Bicycle and Pedestrian Advisory Committee Meeting April 27, 2022 Comments

Subject: 04/27/22 Meeting - Agenda Item 6.2 El Camino Real Pedestrian and Bicycle Improvements - Update

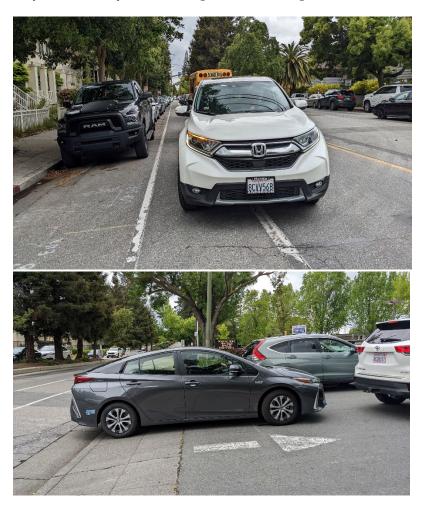
Attached are two recent photos of how drivers treat the bicycle lane and sidewalk in front of Landels Elementary School. The cars in the photos are fully stopped. This is routine: Drivers pulling in to drop off and pick up their kids simply ignore the painted bicycle lanes. I've seen near misses when commuters try to go around the stopped cars, and my bicycling children have had to brake to avoid cars that forced their right of way into the bicycle lanes as pictured in the photos.

And I'd like to see a few permanent cones added to the bicycle lanes in front of Landels as a more visible reminder, since what's there presently is insufficient.
